## THE NORTH EDGE 1405 NORTH FEDERAL HIGHWAY APPLICABLE CODES DELRAY BEACH PALM BEACH COUNTY, FL OCCUPANCY CLASSIFICATION

REVISED 12/01/22  
AS PER DEVELOPMENT SERVICES  
COMMENTS:  
1. UPDATED RENDERING AND  
ADDED RENDERING NOTE.

THIS DRAWING IS NOT FOR CONSTRUCTION,  
IT HAS BEEN ISSUED FOR GOVERNMENTAL  
REVIEW AND/OR PRELIMINARY PRICING.

A/C FLOOR AREA	2,003 S.F.
COVERED PORCH	219 S.F.
TOTAL A/C FLOOR AREA	2,003 S.F.
TOTAL FLOOR AREA UNDER ROOF	2,222 S.F.

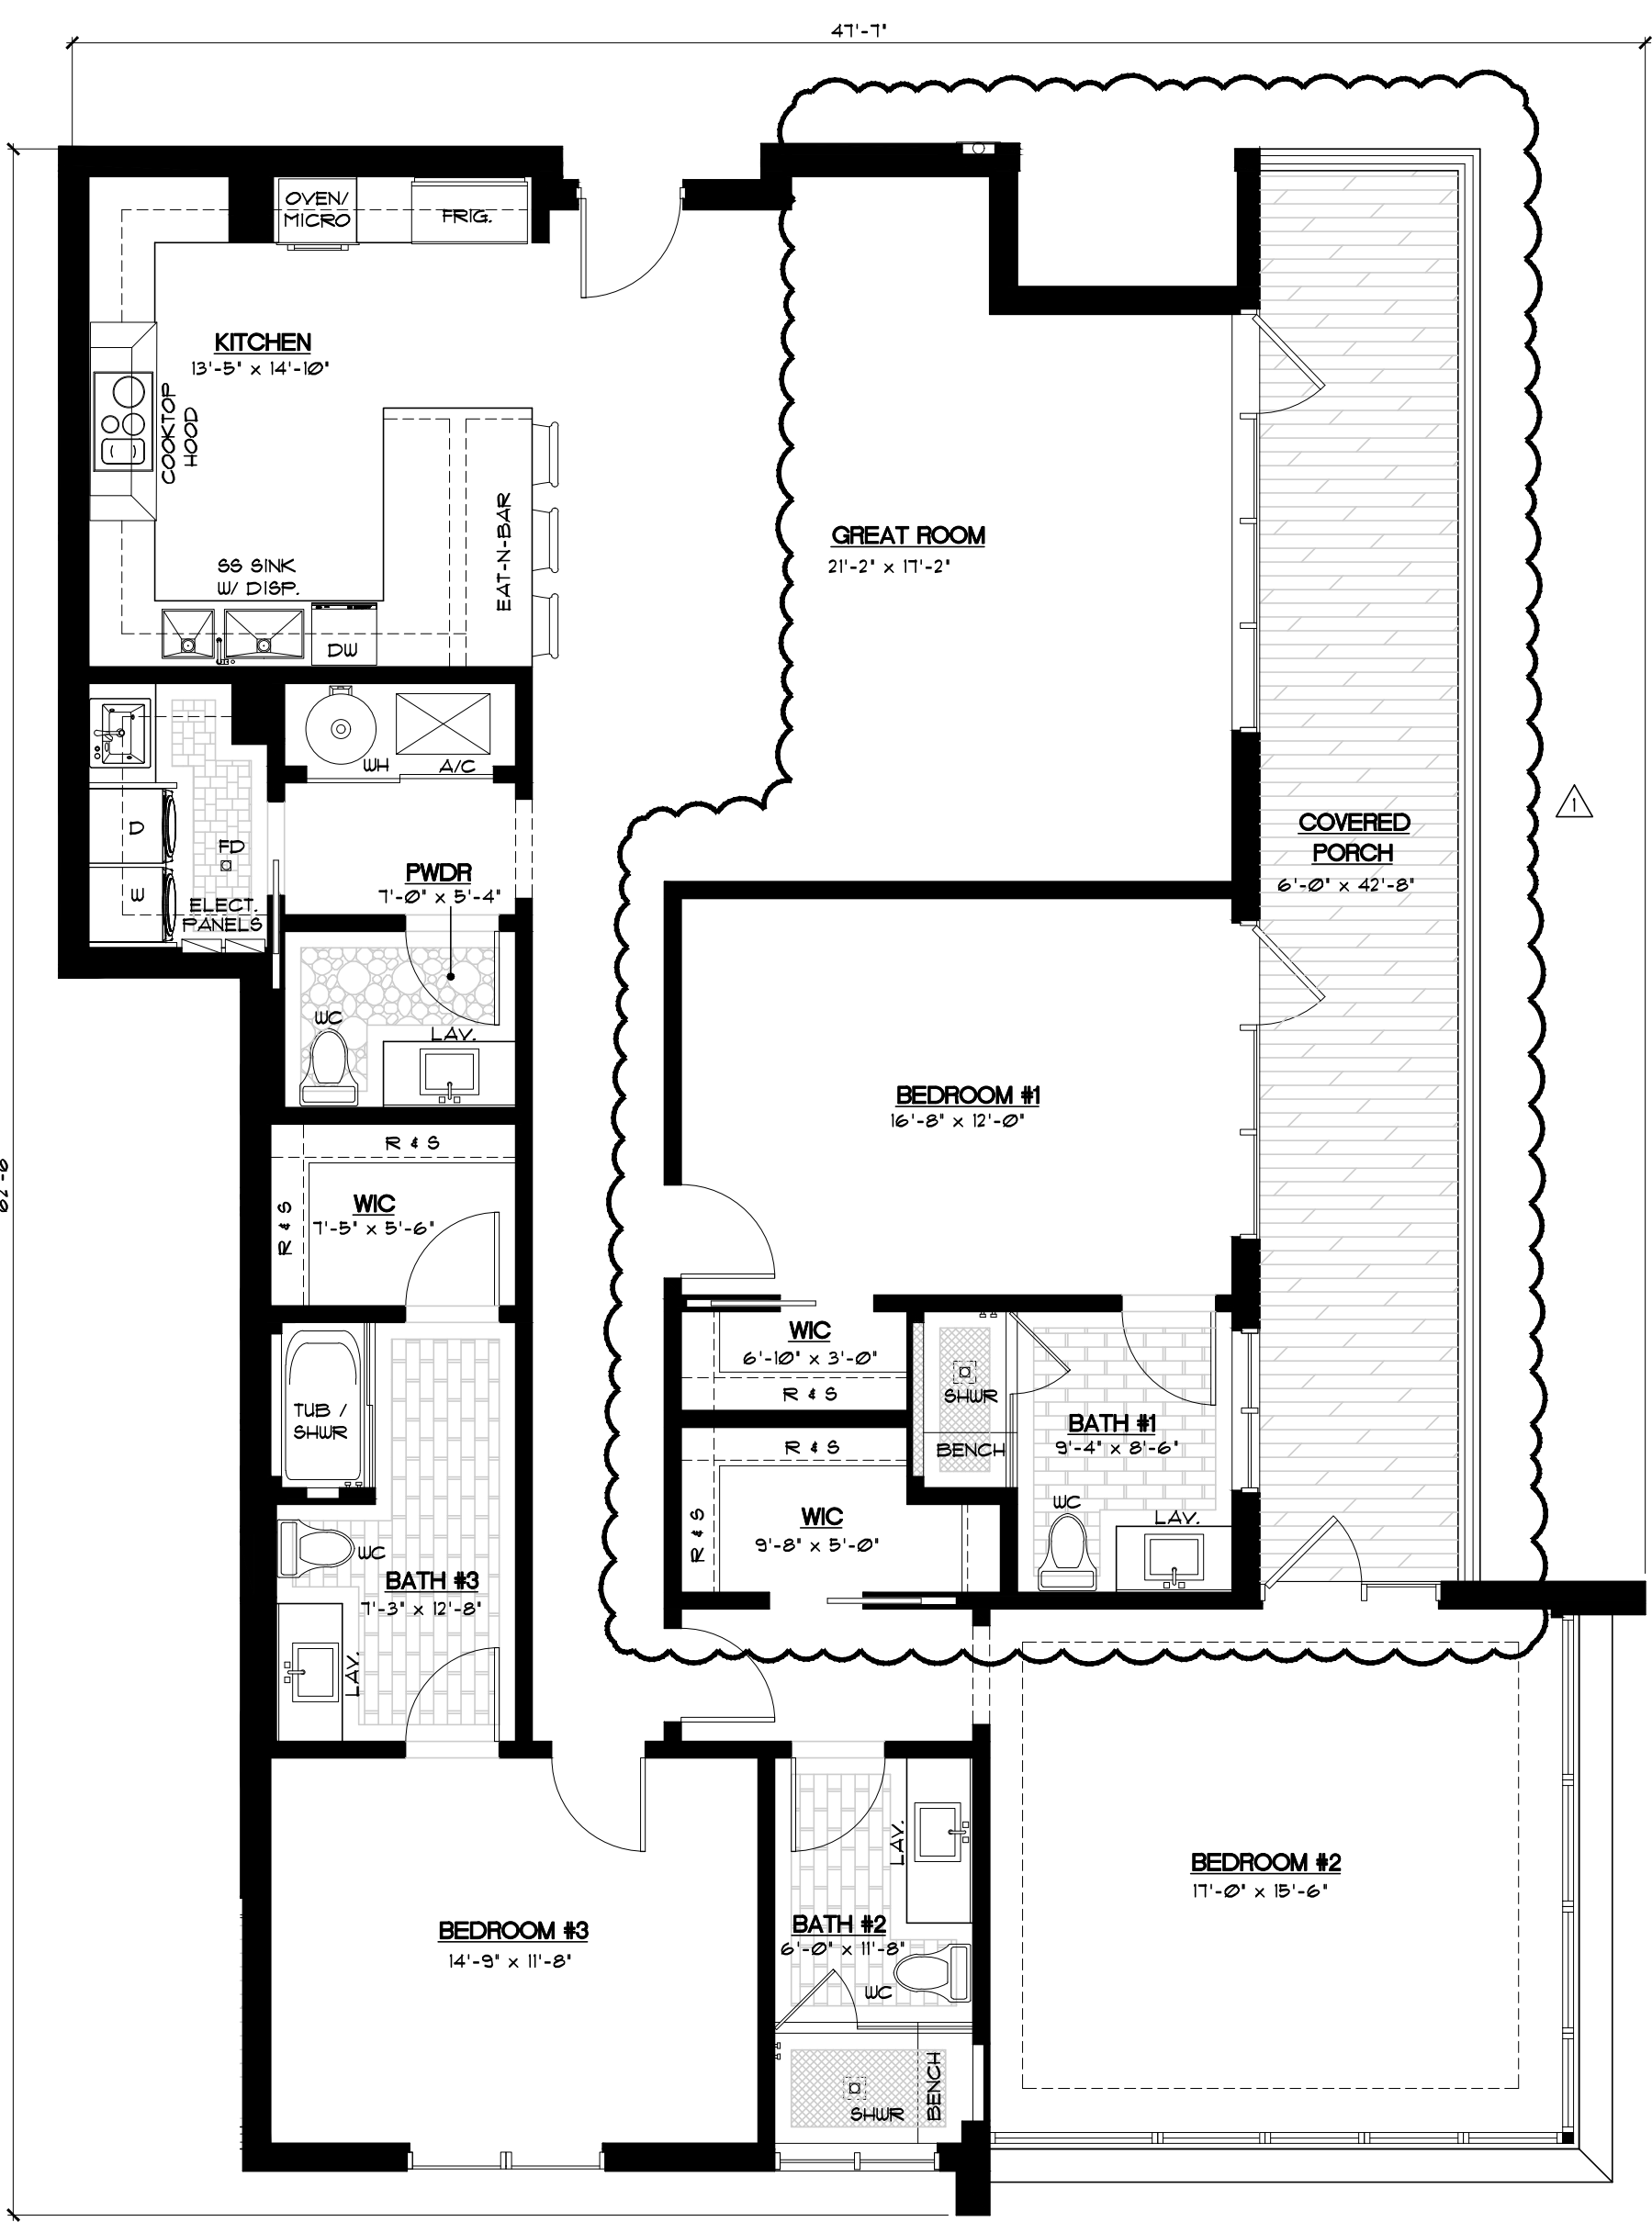
REVISIONS  
▲ REVISED 12/3/22  
AS PER DEVELOPMENT SERVICES COMMENTS:  
1. UNIT 202; MADE PORCH #1 SMALLER  
2. UNIT 204; MADE PORCH LARGER  
3. MOVED THE TRASH CHUTE LOCATION TO THE WEST

DRAWING TITLE  
**BUILDING SECTIONS**

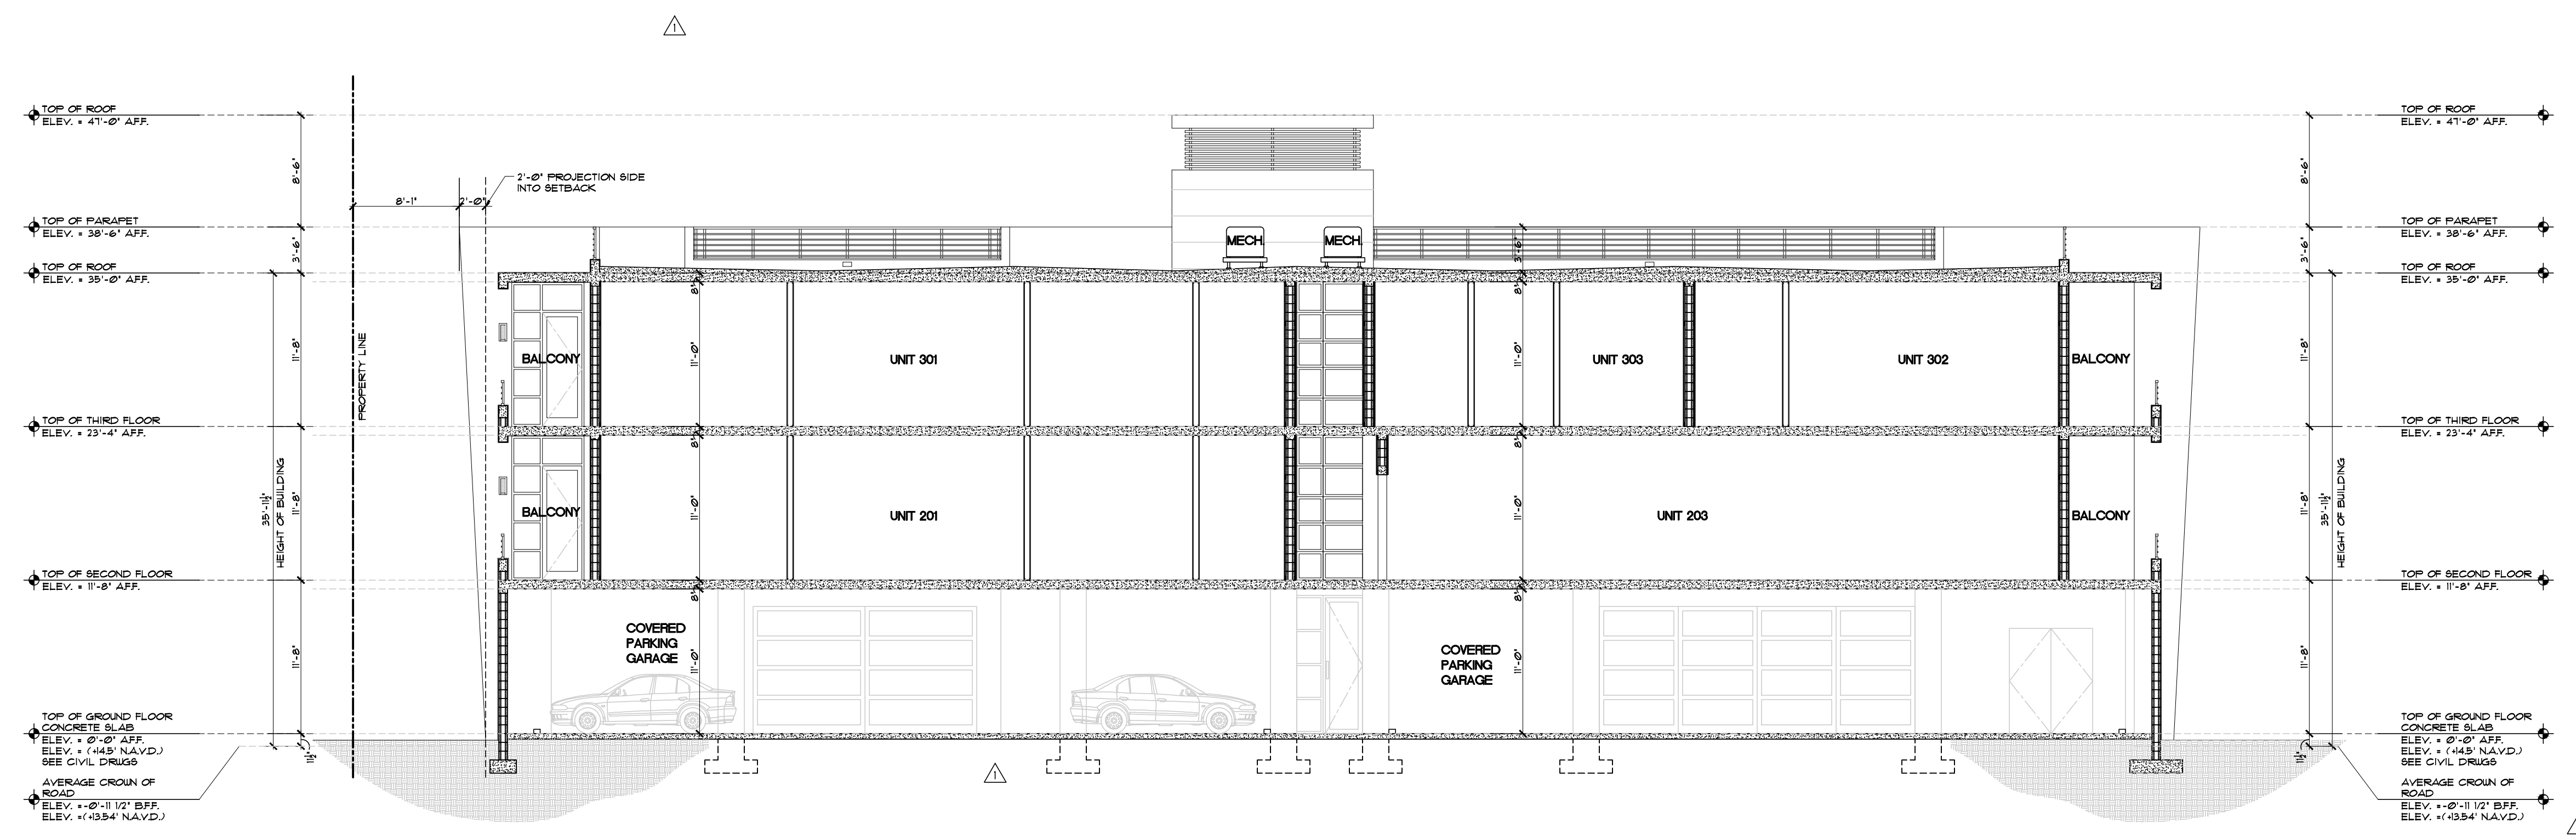
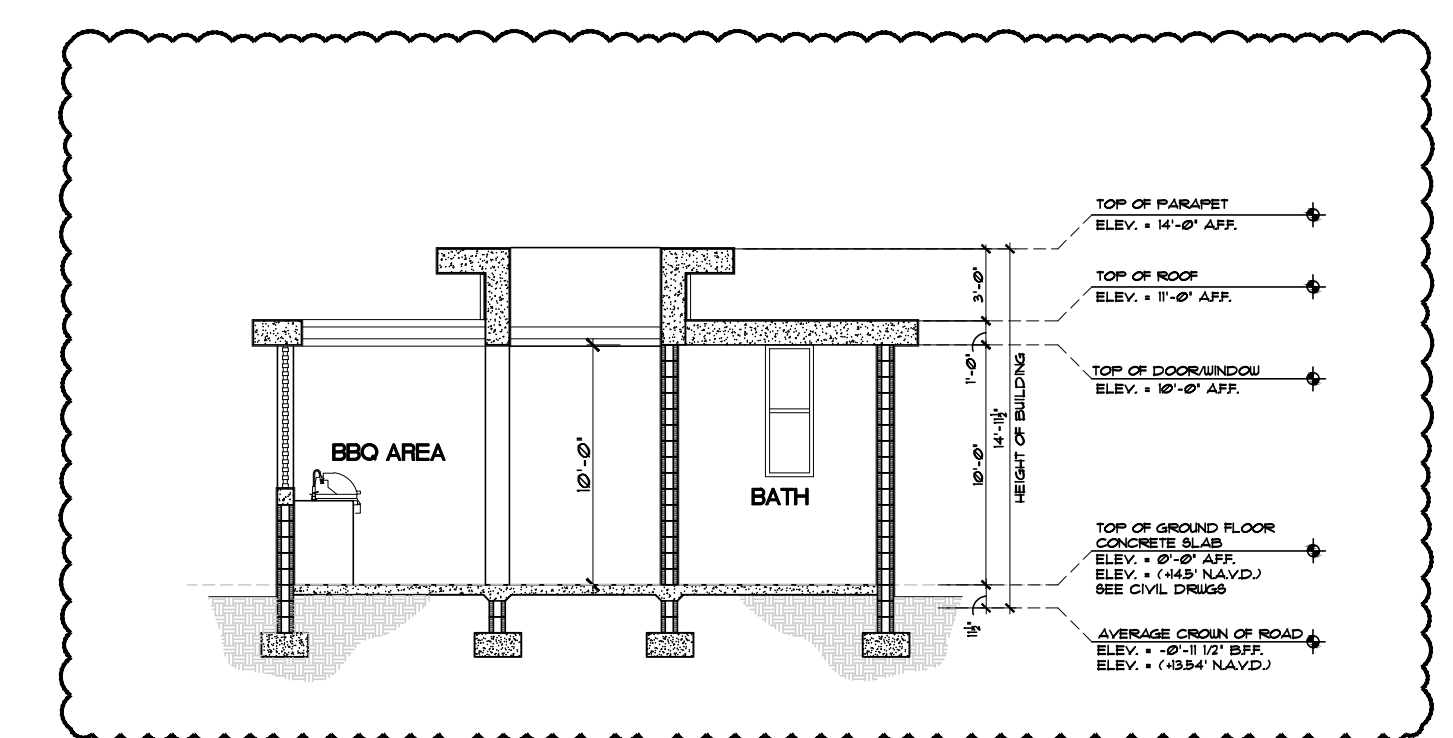
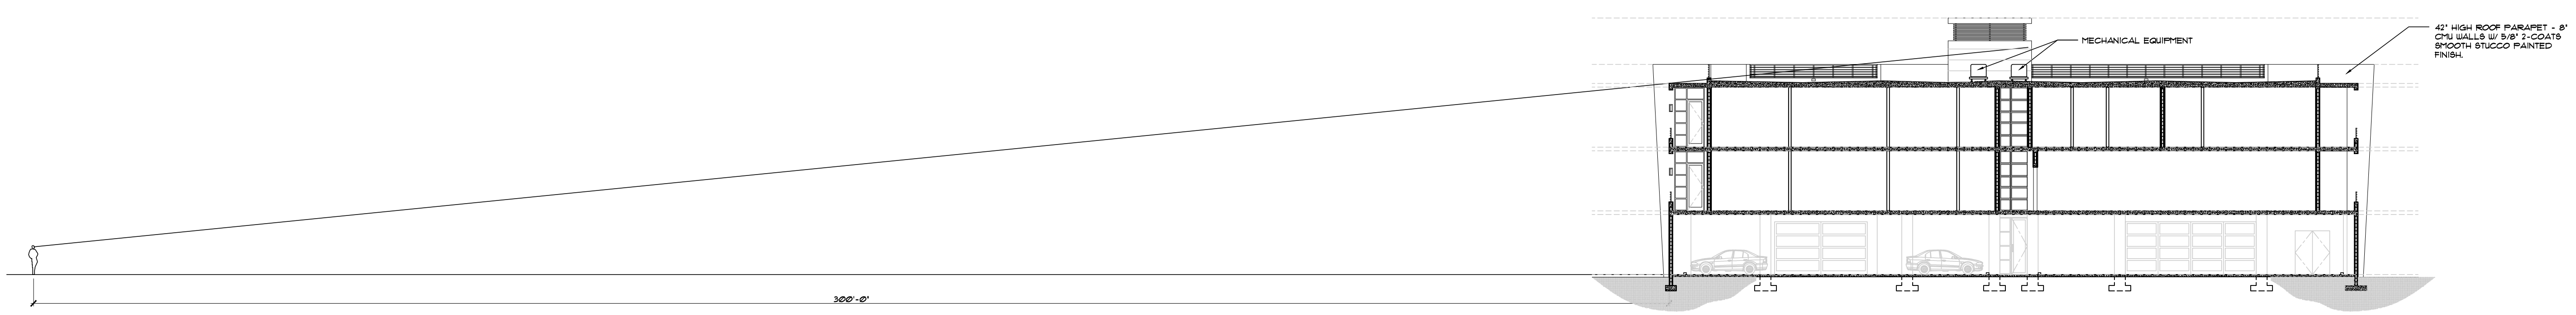
REVISOR	DATE	DESCRIPTION
AS PER DEVELOPMENT SERVICES	12/23/22	ADDED AVERAGE CROWN OF ROAD TO SECTIONS
AS PER DEVELOPMENT SERVICES	12/23/22	UPDATED SIZE OF GARAGE DOOR TO 11'-0"
AS PER DEVELOPMENT SERVICES	12/23/22	ADJUSTED STAIR TOWER AND RAILINGS AT ROOF LEVEL
AS PER DEVELOPMENT SERVICES	12/23/22	MADE AMENITY BUILDING SMALLER
AS PER DEVELOPMENT SERVICES	12/29/22	REDUCED SQUARE FOOTAGE OF AMENITY BLDG.
